SUBJECT: **CONDITIONAL USE / CLASS 3 SITE PLAN REVIEW / CLASS 2
ADJUSTMENT CASE NO. CU-SPR-ADJ24-02
325 LANCASTER DRIVE SE – 97317
AMANDA NO. 24-103944-PLN**

Summary: A Conditional Use Permit, Class 3 Site Plan Review and Class 2 Adjustment for a Residential Care Facility.

Request: A consolidated application for a Conditional Use Permit and Class 3 Site Plan Review to construct a Residential Care Facility and associated site improvements with a Class 2 Adjustment to reduce the perimeter setback landscaping and plant units for the undeveloped portion of the development site. The subject properties are 5.57 acres in size, zoned CG (General Commercial) and located at 325 Lancaster Drive SE (Marion County Assessors Map and Tax Lot Numbers 072W31BB / 4501).

ENLARGED SITE PLAN

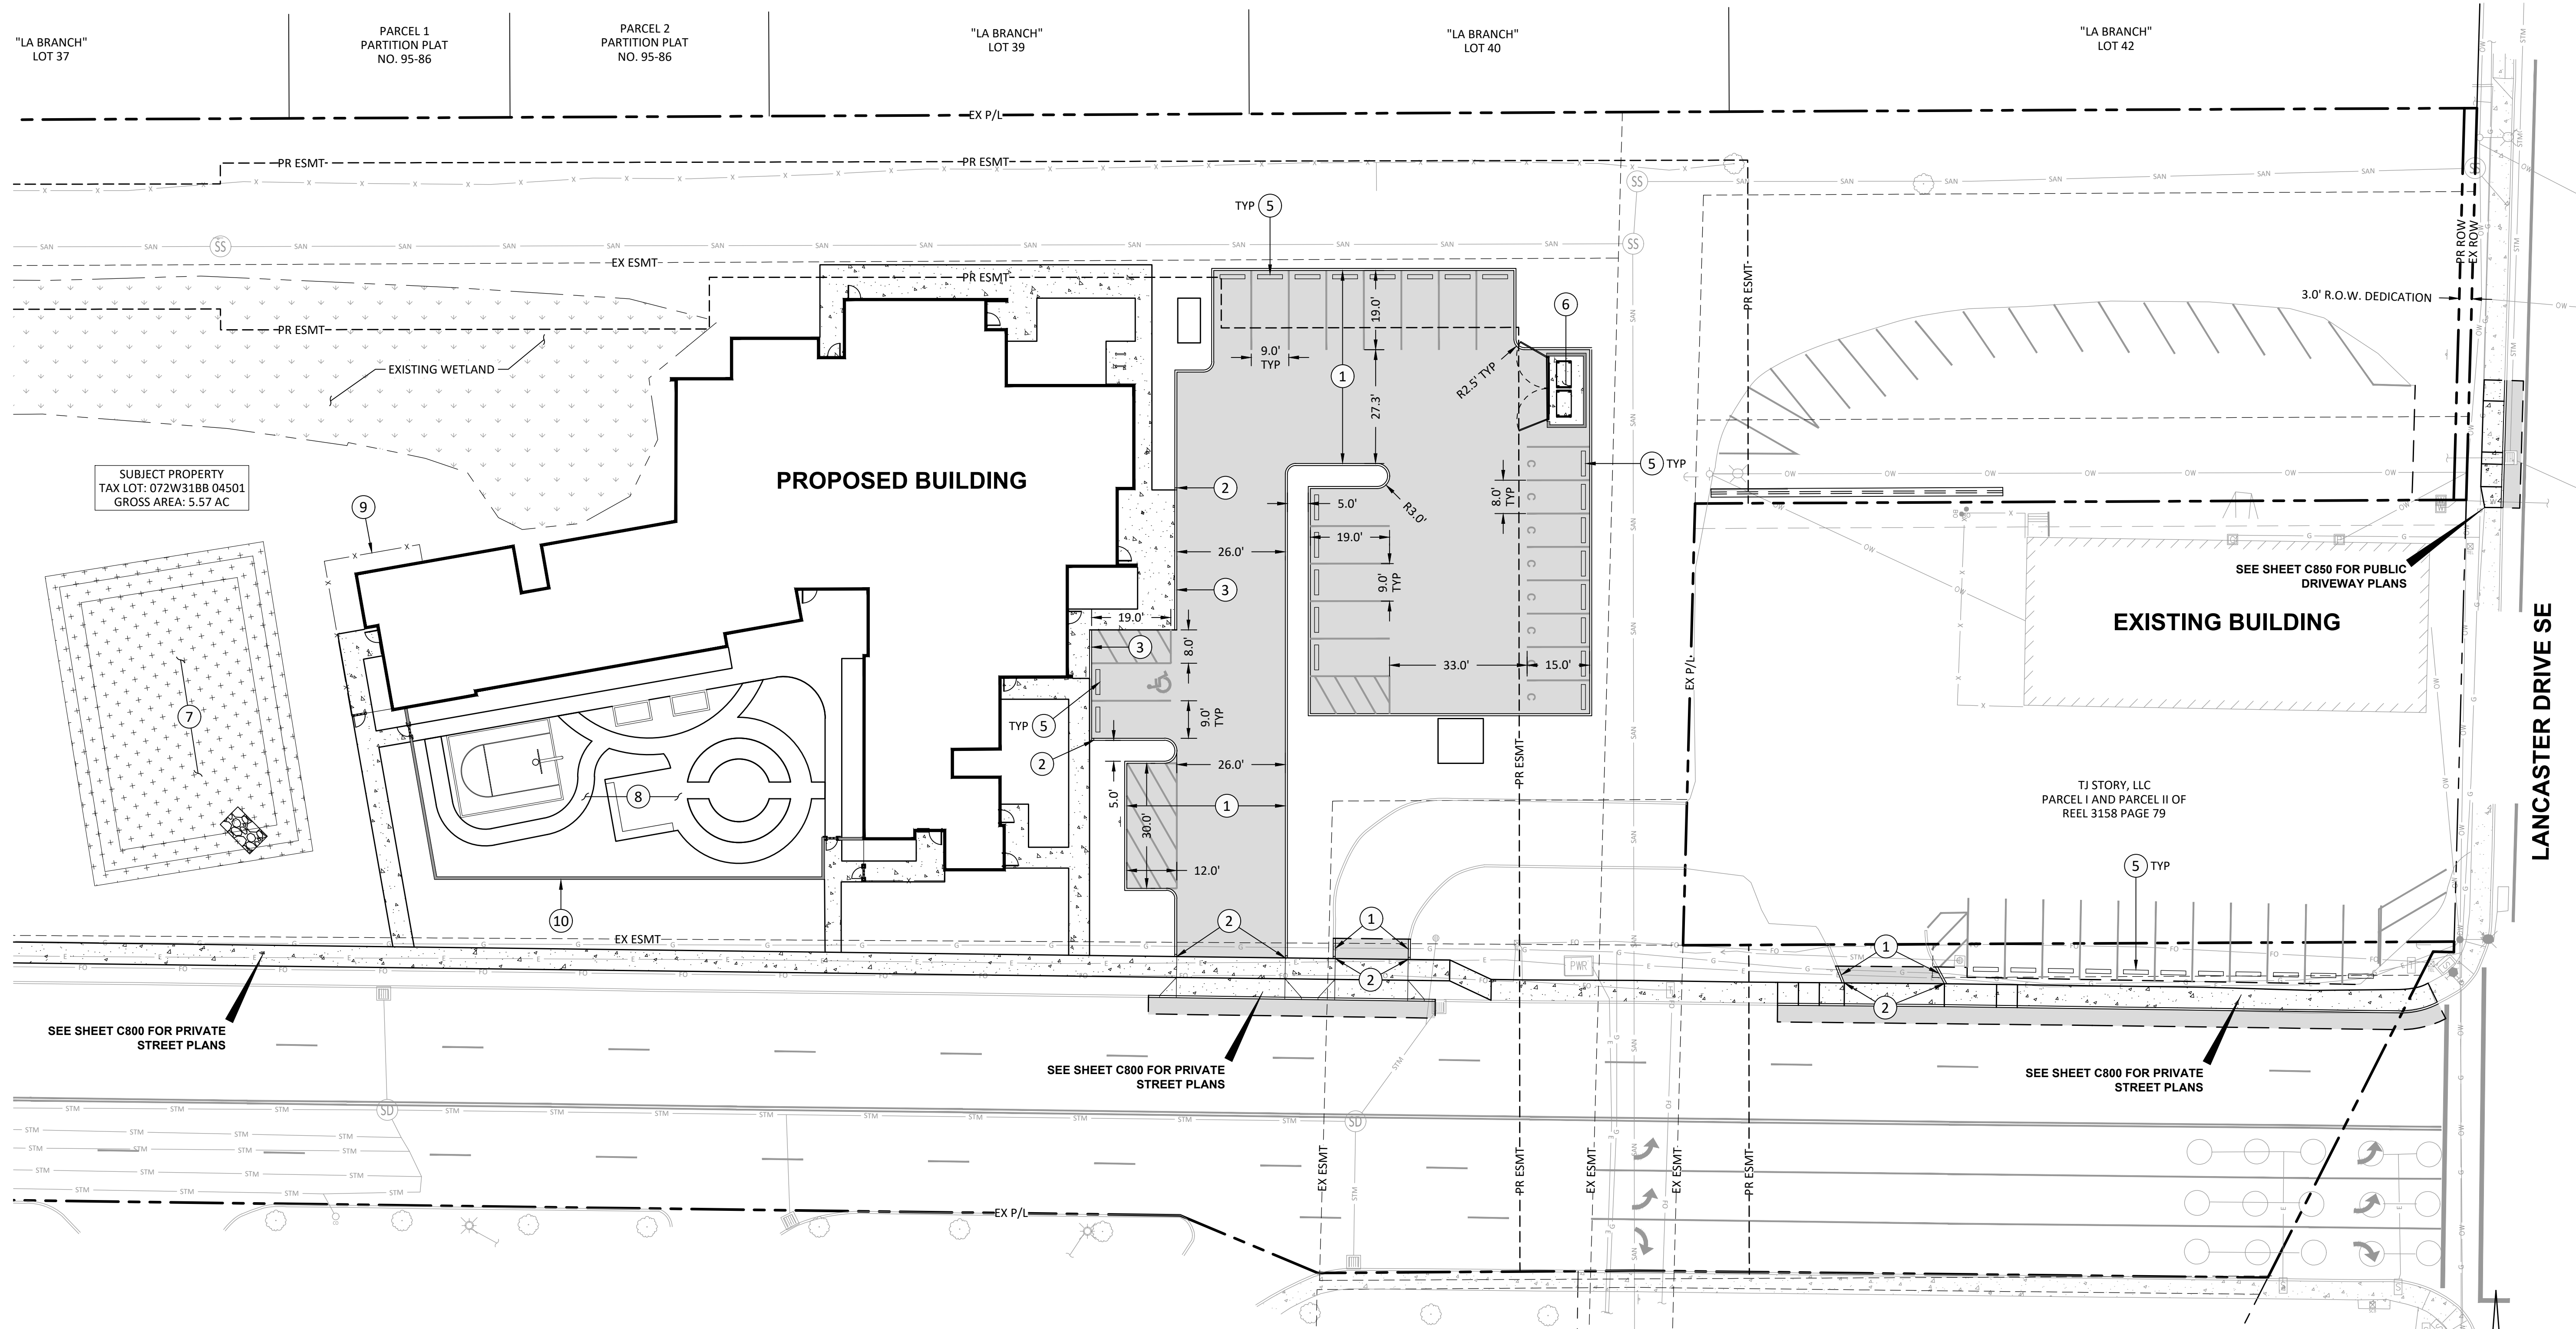
Finding: The proposed building and vehicle use area is located more than 40-feet from any property line, meeting the above requirements. There is an unauthorized parking area located on the northeastern portion of the property, which is not within the scope of the proposed project. In order to prevent the continued use of the parking area, the applicant has proposed a jersey barrier between the abutting property and the parking area preventing access. As discussed below, the driveway to this area will be closed as a condition of approval. To ensure the unauthorized parking area is not used until permits are issued the following condition applies:

Finding: The proposal includes a new new solid waste service area. The proposed trash enclosure is located within a City Easement, where structures are not permitted. As addressed below, the trash enclosure shall be located outside of the public easement. The applicant has not provided adequate detail to address the standards nor the existing easement, therefore the following condition applies:

The applicant's preliminary site plan shows a trash enclosure, trees, and parking within the required easement. Pursuant to SRC 802.020 buildings, structures, trees, or other obstructions other than landscaping shall not be located in City easements. The surface parking can be permitted within the sanitary sewer easement with a revocable license to encroach; however, trees and the trash enclosure shall be relocated to outside of the sanitary sewer main easement so as not to obstruct access to the City's main.

applicant's site plan shows placement of a jersey barrier to block vehicle traffic from utilizing this driveway approach and unpermitted parking area. As a condition of approval, the applicant shall be required to permanently close the driveway approach and replace with curbs and sidewalks in accordance with Marion County construction standards.

The proposed landscaping plan has two trees located within the interior landscaping areas but will require an additional tree in the planter bay labeled 'E', therefore the following condition applies:

Condition 3: Prior to issuance of any building permits, the applicant shall install a jersey barrier between the unauthorized parking area on the northeastern portion of the property and 375 Lancaster Drive SE.

Condition 5: At the time of building permit, the applicant shall revise the site plan to relocate the trash enclosure outside of the required easement for existing public utilities.

Condition 8: At the time of building permit, the applicant shall submit a final landscaping plan that relocates the trees within the required easement for existing public utilities to another location on the site.

Condition 10: Permanently close the northerly driveway onto Lancaster Drive NE as shown on the applicant's preliminary site plan and replace with curbs and sidewalks in accordance with Marion County construction standards.

Condition 12: At the time of building permit, the applicant shall include one tree within the planter area labeled 'E' on the landscaping plan.
